**STAFF REPORT:** 11/10/2021 MEEETING

**ADDRESS:** 8016 KERCHEVAL

**APPLICATION NO:** #21-7581

**SCOPE:** ERECT DECK BETWEEN EXISTING FRONT PORCHES; REPLACE WINDOW WITH DOOR; INSTALL ADA LIFT AT REAR PORCH; AND ERECT DUMPSTER ENCLOSURE IN PARKING LOT

**1 FIRST FLOOR - FLOOR PLAN**  
SCALE: 1/4"=1'-0"

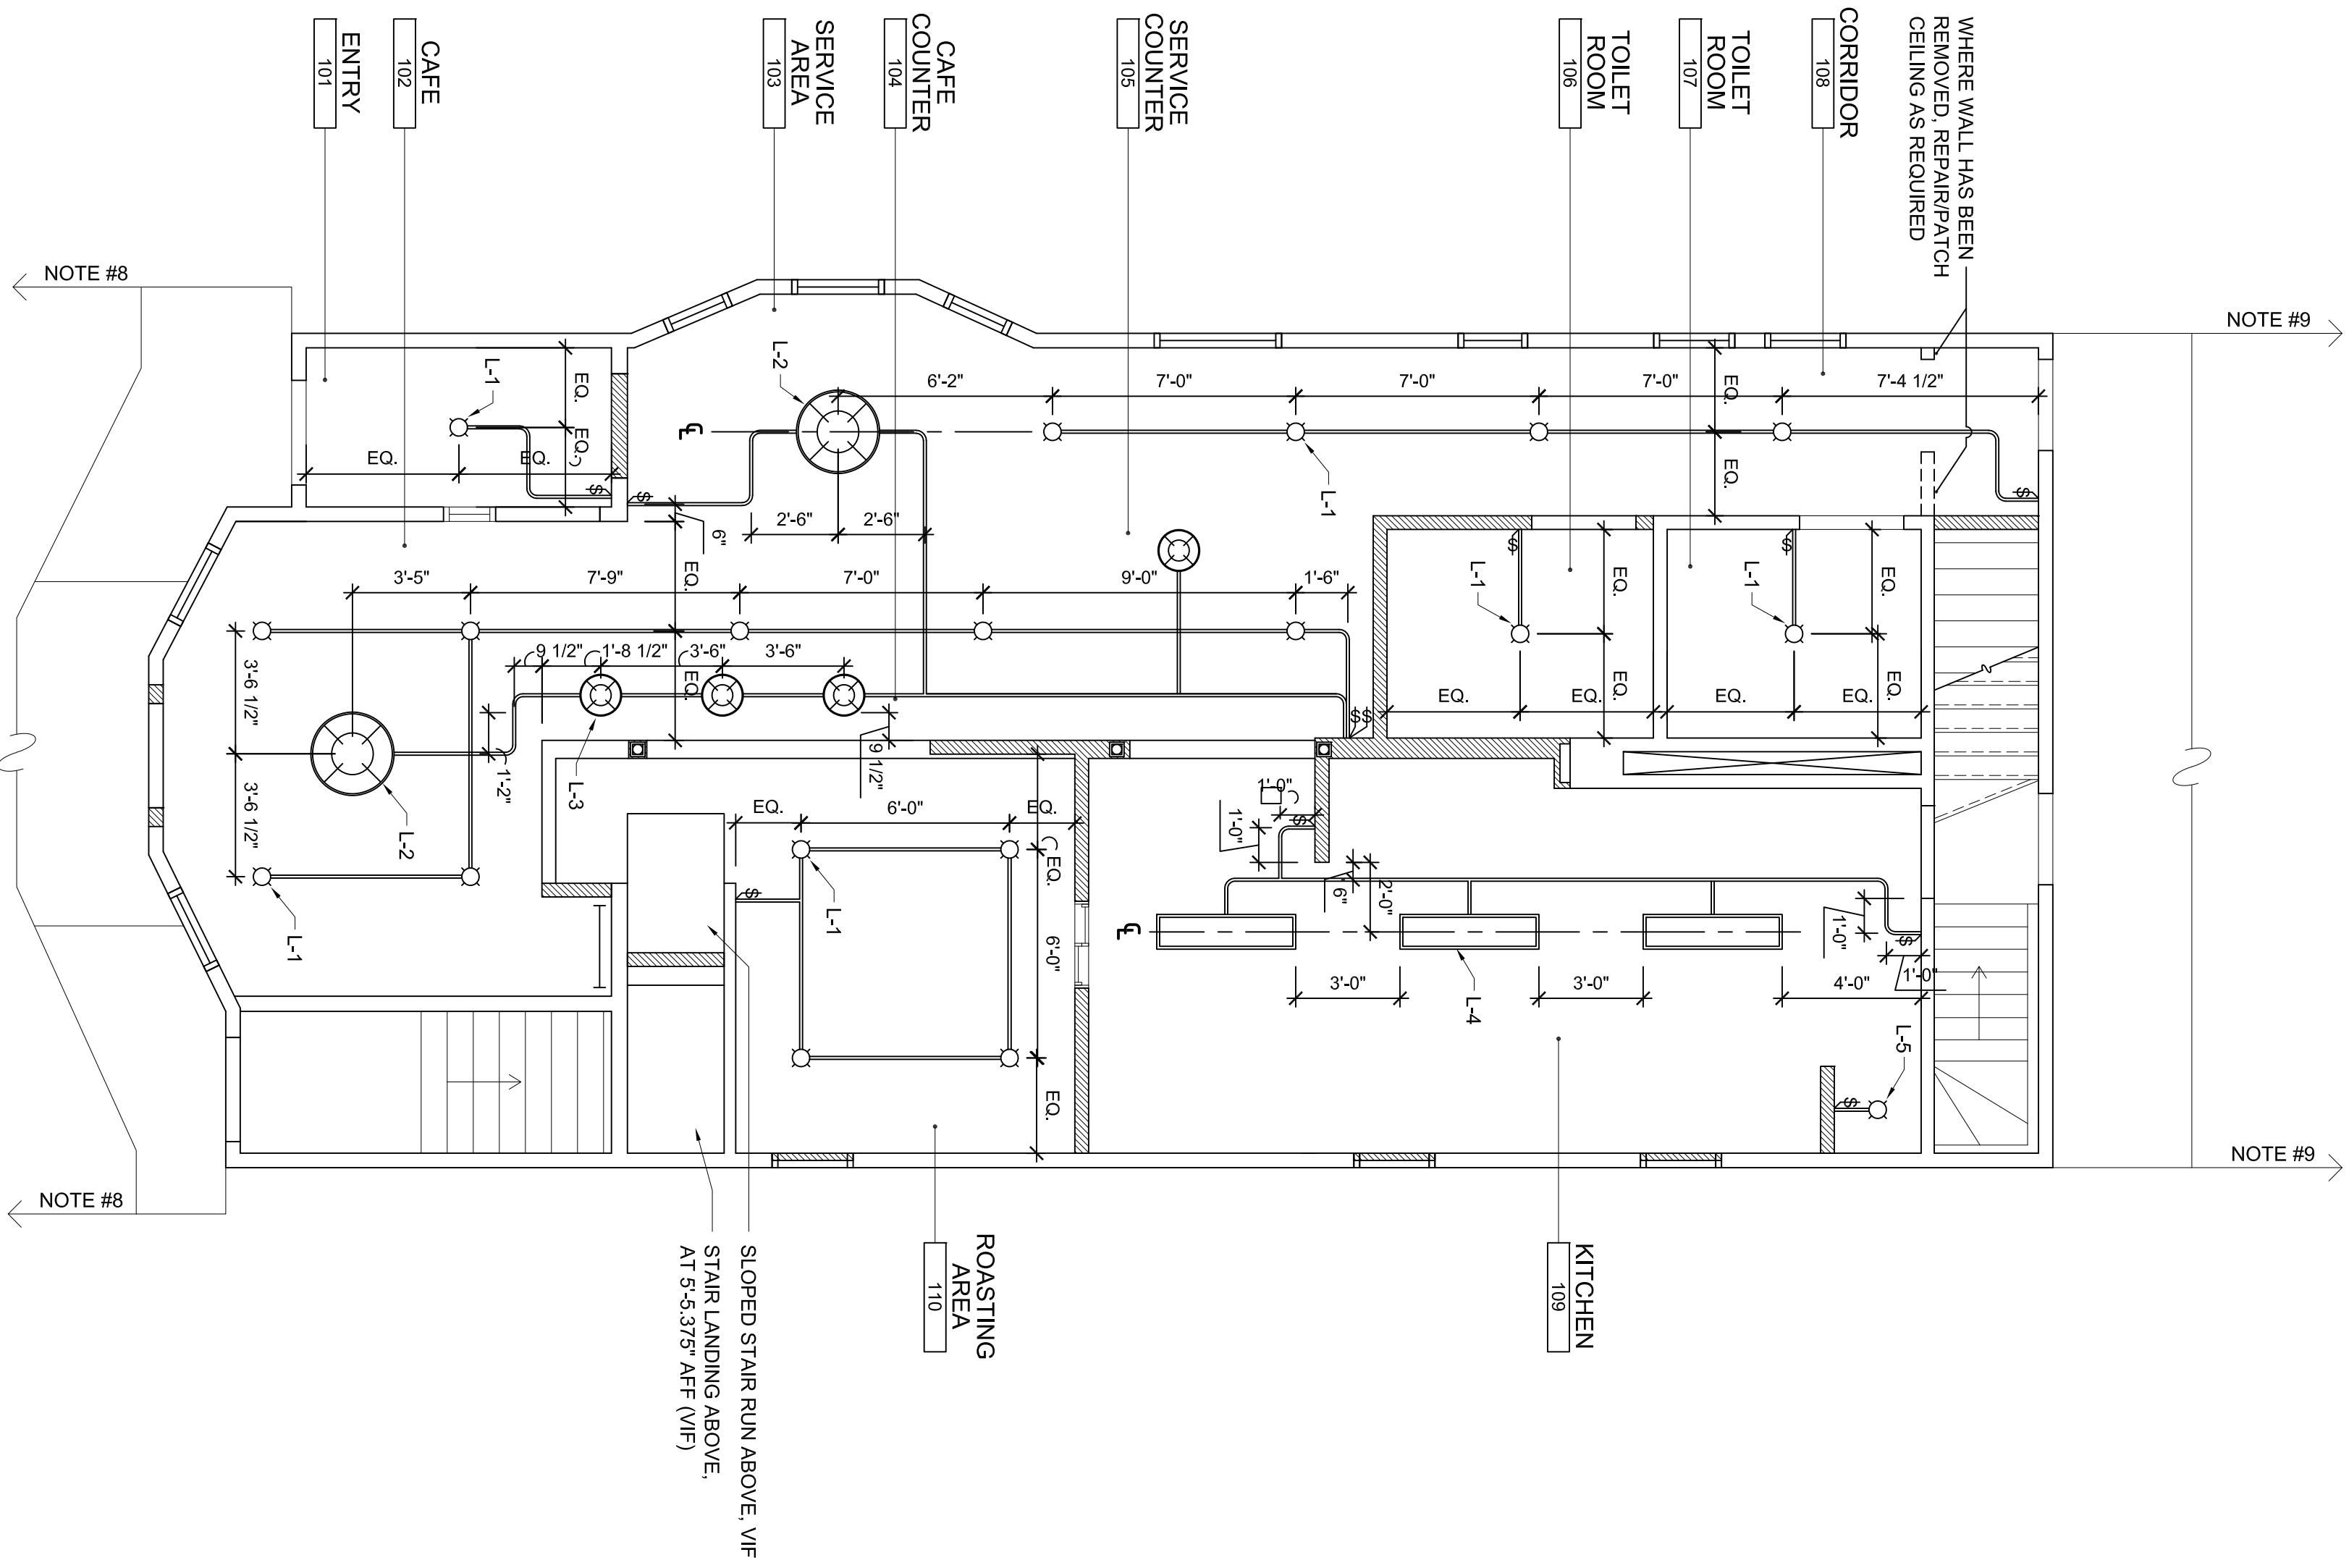
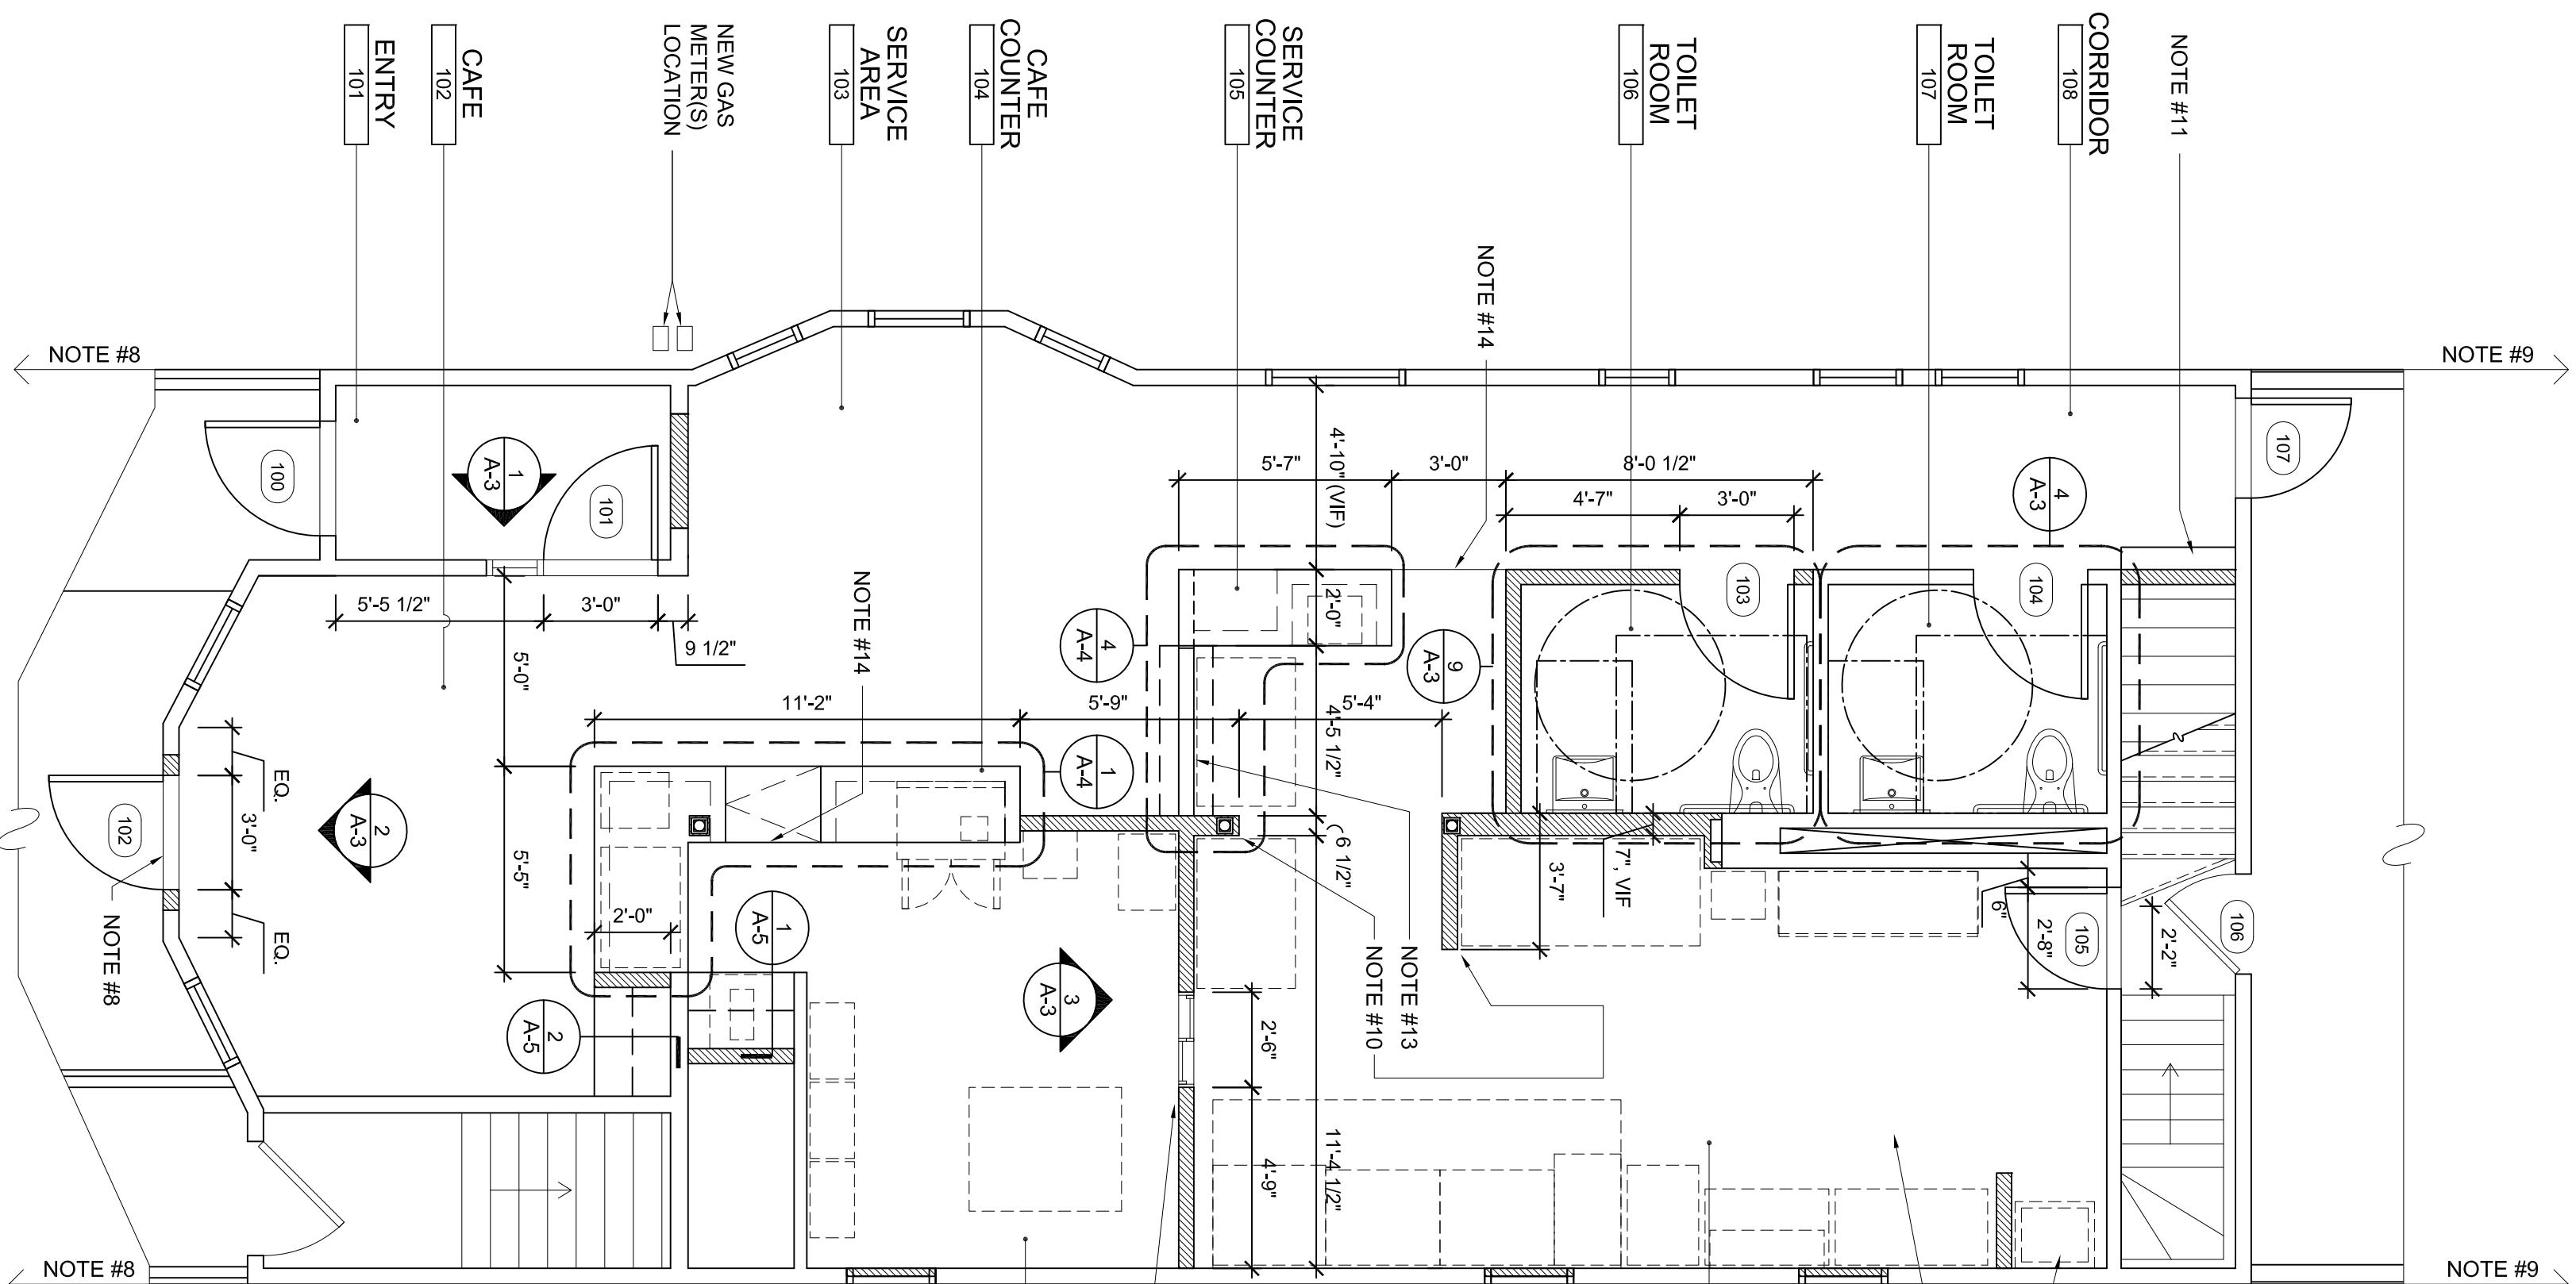
- It is staff's opinion that the front elevation window proposed for removal and replacement with a door and trim is a character-defining feature of the property. See the submitted proposed first-story floor plan. The new deck/outdoor patio space, if approved, will be accessible via the eastern door.
